CONSERVATION COMMISSION DETAILED AGENDA

Posting Date: June 16, 2023
Meeting Date: June 22, 2023
Time: 6:00 pm

PROPOSED SITE PLAN
PREPARED FOR
WILLIAM J. & DENISE E. GRUDZIEN
3 DOUTY ROAD, STURBRIDGE, MASSACHUSETTS

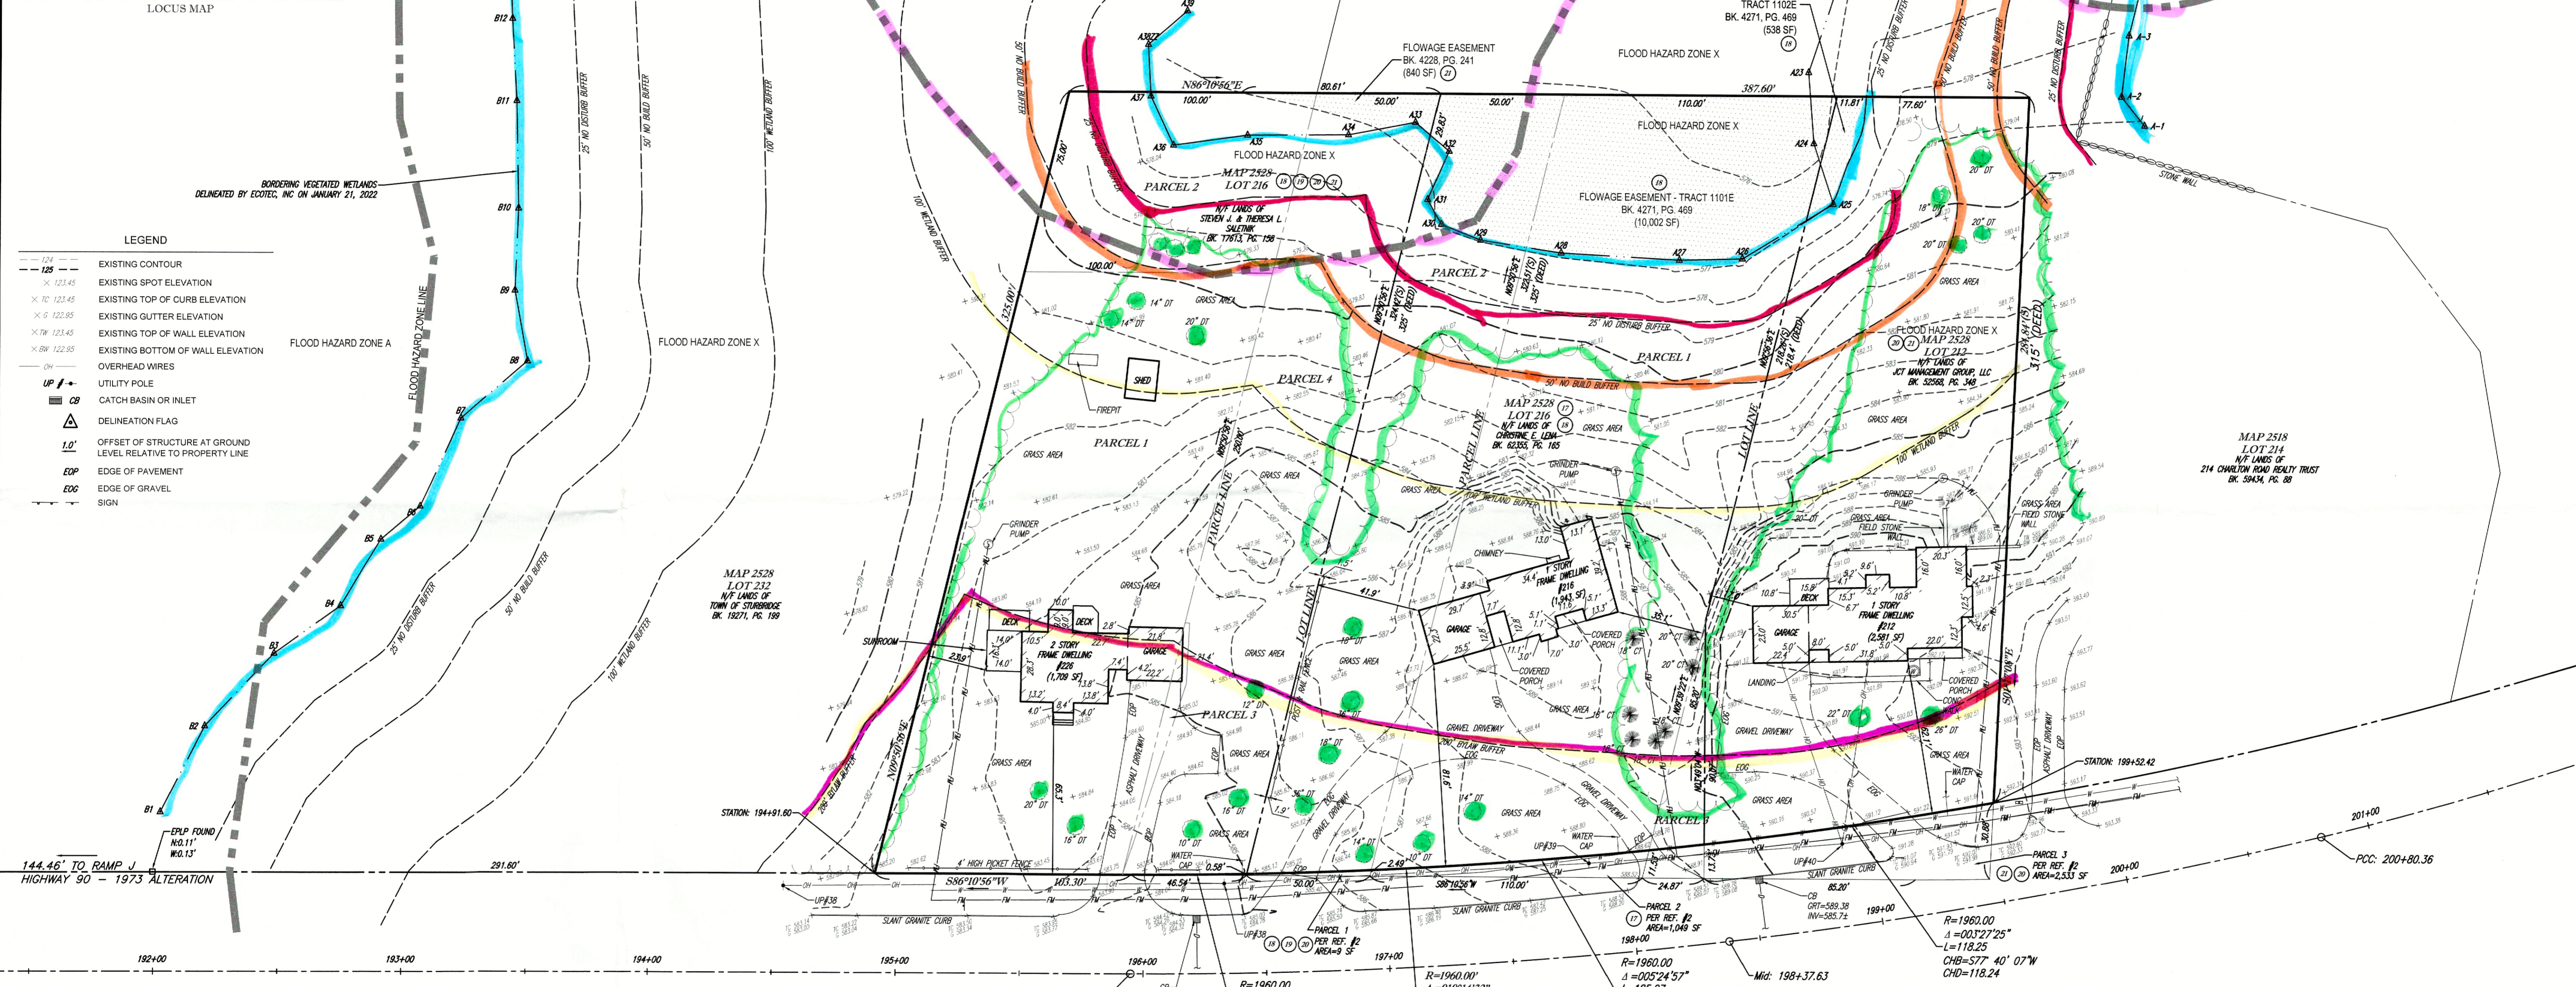
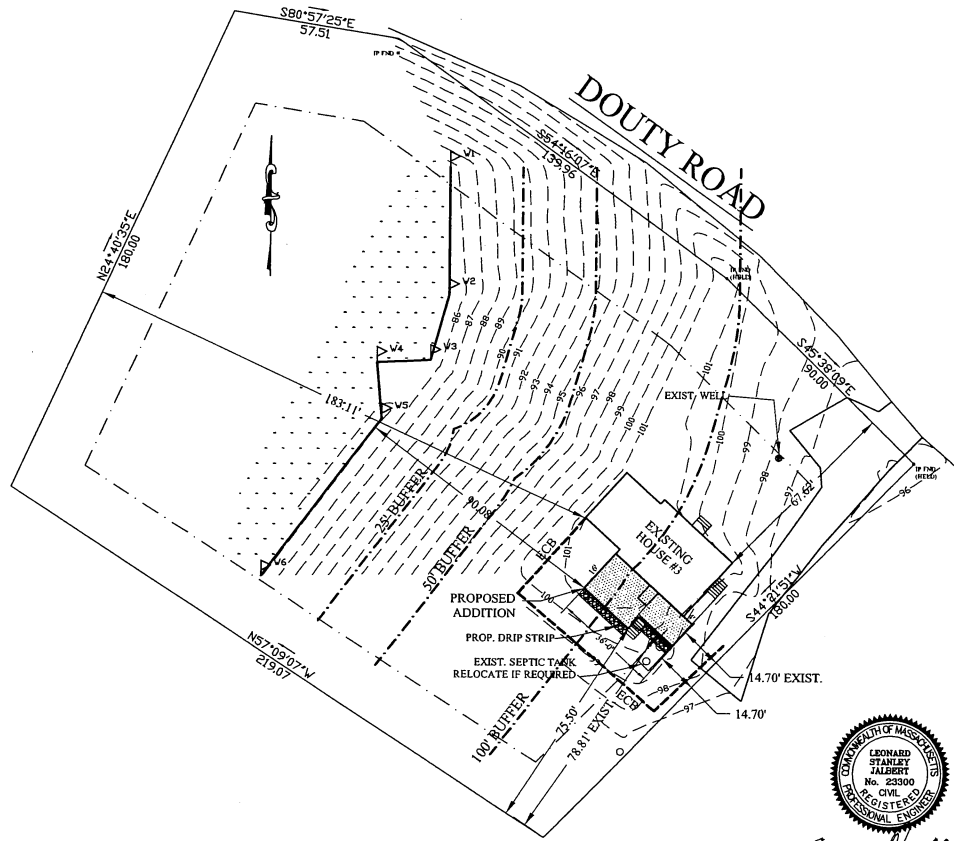
- Owner/Applicant: William Grudzien Representative: Owner
- Request: Issue DOA
- Documents Presented: colored plans
- Project Summary: Project including a 500 ft house addition in a developed lawn built on piers as the site conditions will not allow a foundation. No trees or shrubs will be removed as part of this project.

- Work is considered minor. All work is within a developed yard. Work area slopes away from wetland. Wetland appears to be a vernal pool. No expansion of developed areas proposed.

- ECs don't appear necessary. Any stockpiling that may be necessary can be protected or deposited on east side of lot (away from wetlands).
- Staff Recommendation: Close the hearing and issue a DOA:

- Negative #3 with conditions:
 - Standard pre-work and sign off conditions.
 - Any stockpiling that may be necessary can be protected or deposited on east side of lot (away from wetlands).

TITLE: **SOIL EROSION & SEDIMENT CONTROL PLAN**

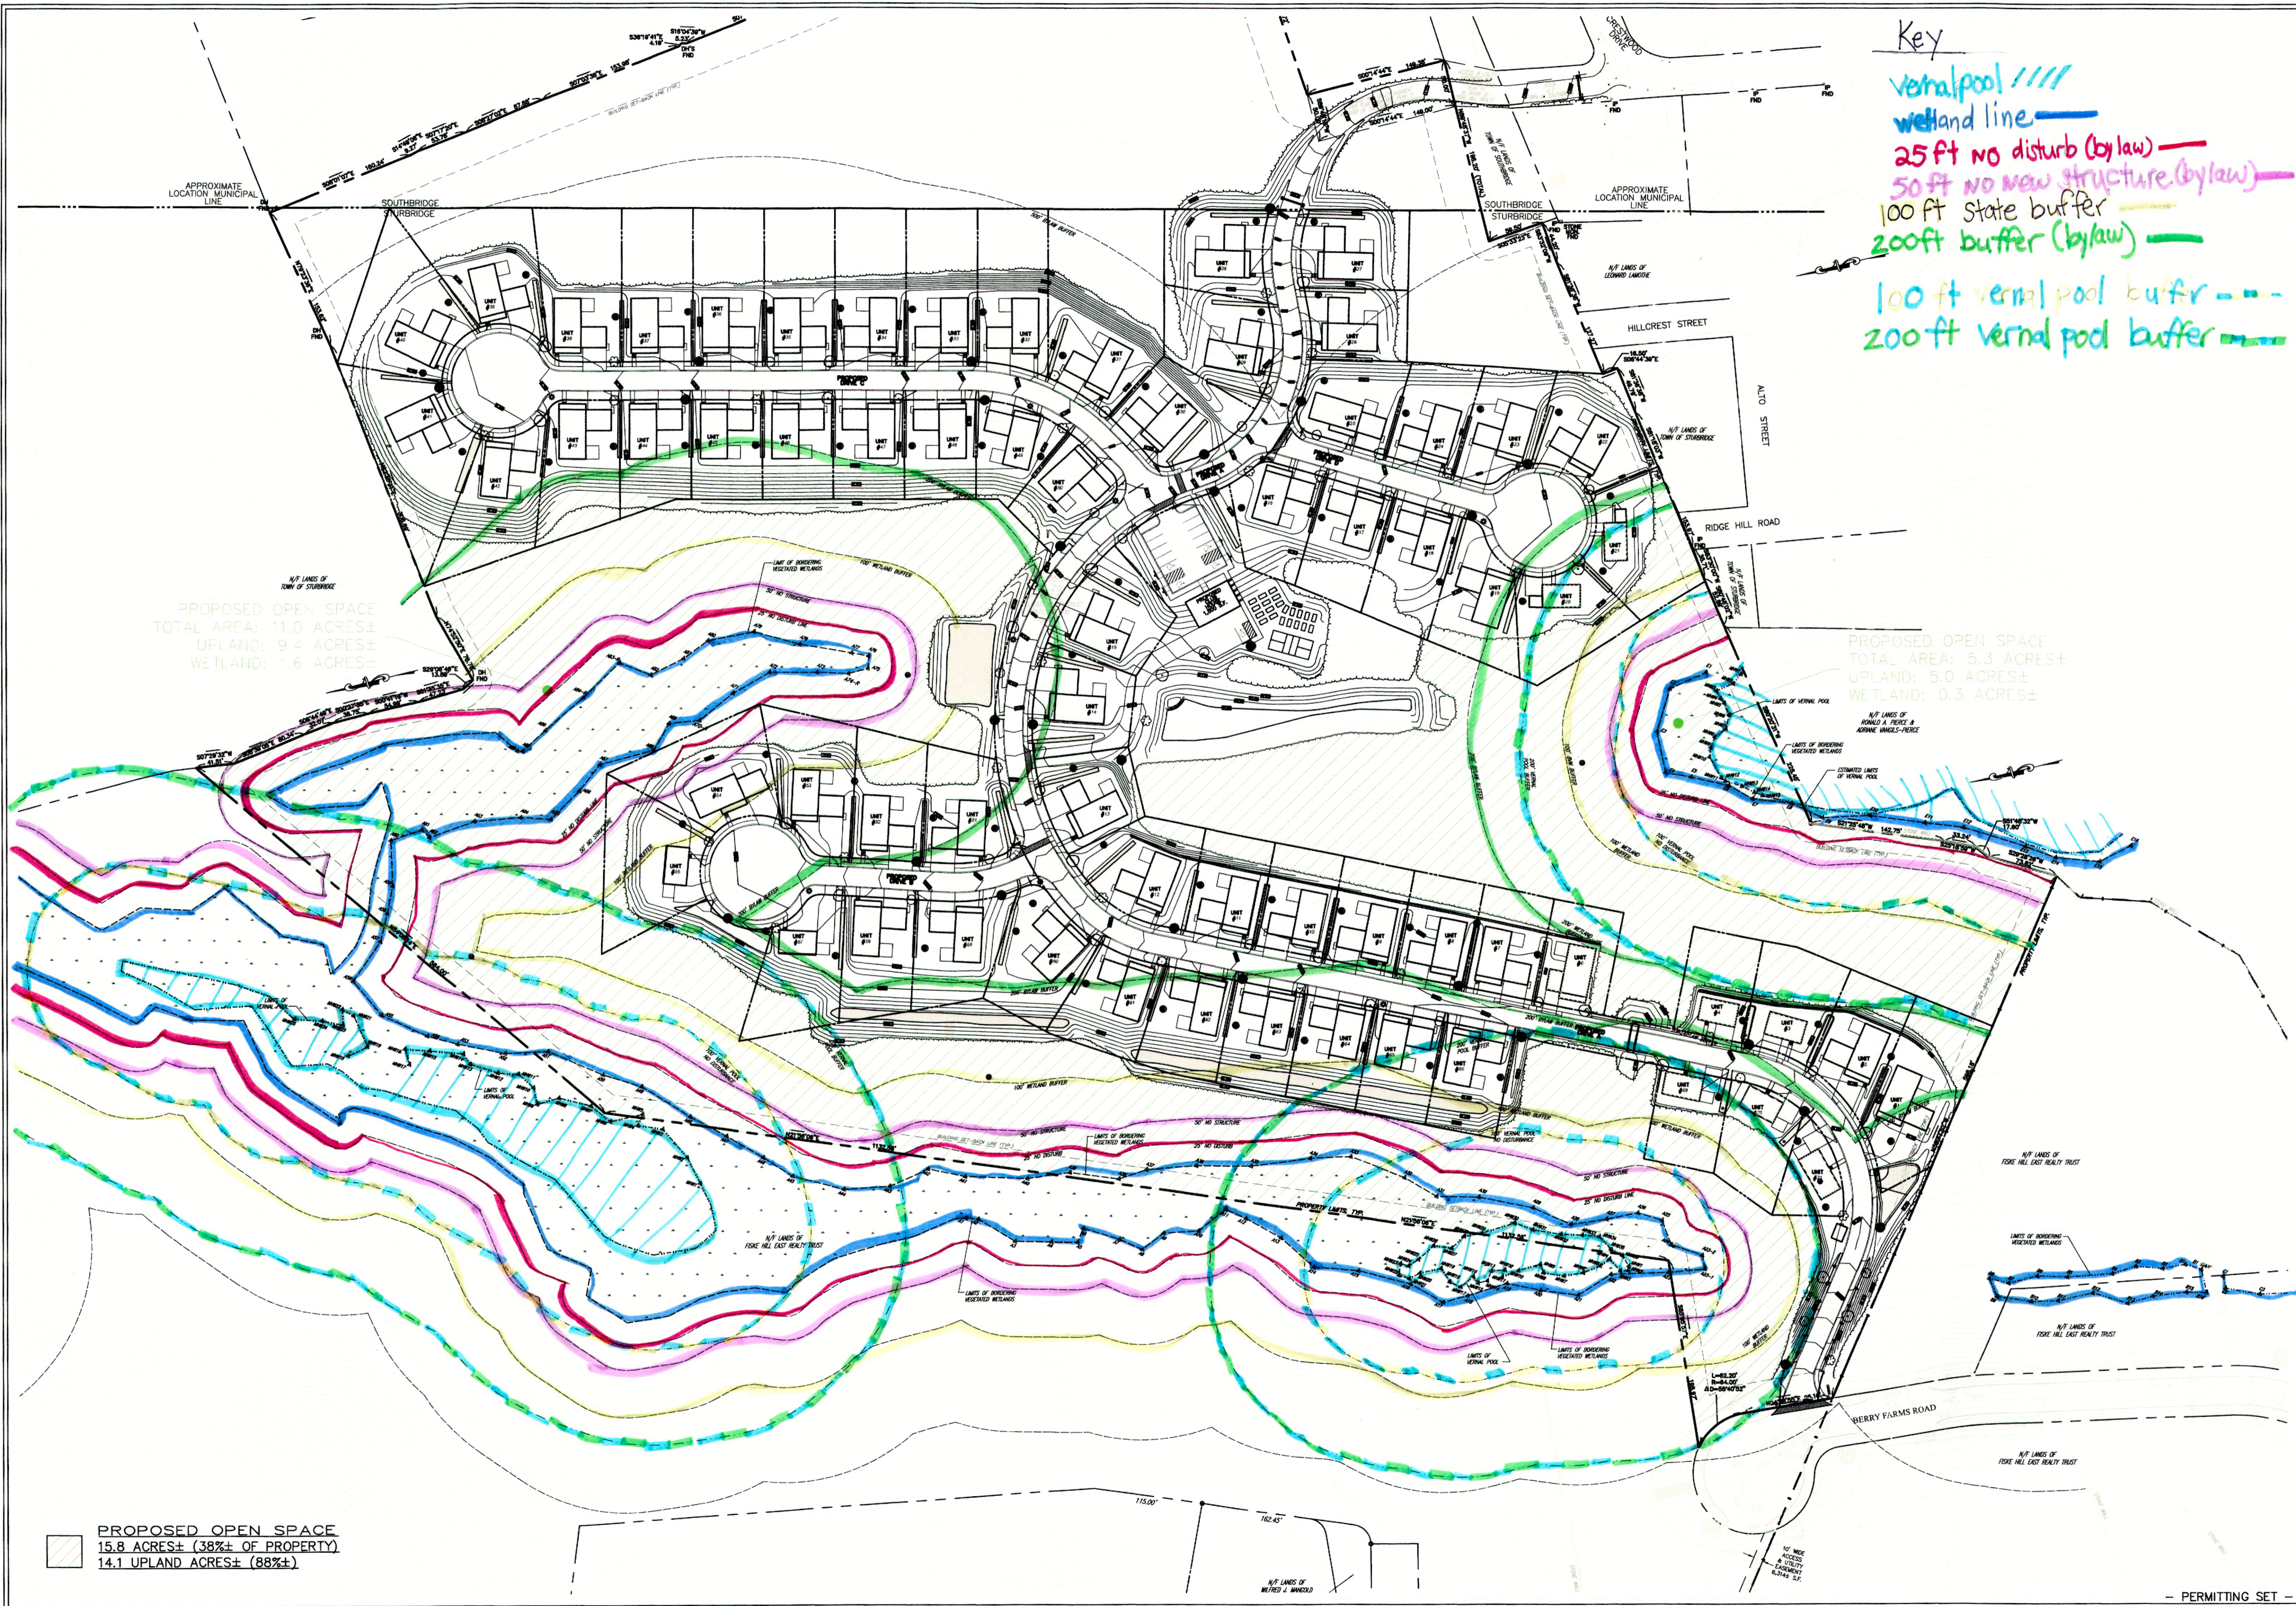
- Existing conditions plan show wetland flags, however, site plan set does not show wetland flags. Notes wetland areas but not flags. Plans will need to be updated to include wetland flags. Hobbs Brook is a perennial stream. Noted in wetland report that no flow observed and ponded, therefore, no Riverfront Area shown. This needs to be reviewed. There is also a stream to the east of the property which may project a 200 foot buffer zone slightly on the property. Wetland flagged in Jan. of 2022. Bordering Land Subject to Flooding noted on site. Plan appears to reflect GIS mapping.

This is a zone A so engineer review is required to determine flood elevations. Resource verification required. Due to nature of project and questions, staff recommend a peer review for this.

- Commercial project which requires stormwater compliance. Will result in an increase in impervious surfaces. This requires peer review. Flood zone elevations require verification for bordering land subject to flooding.
- Revised application needs to be submitted to DEP. Receipt of mailing in the filing shows April date.
- Staff Recommendations: Vote for peer review of resource area verification and for P.E. review of engineering, flood elevations, and stormwater compliance. Continue to next meeting to allow for solicitation of proposals. Site visit should be scheduled once peer reviews have been conducted unless the board would like to review sooner. Site requires staking as outlined in SWB Regulations for site visit and may be needed for peer reviews especially engineering review.
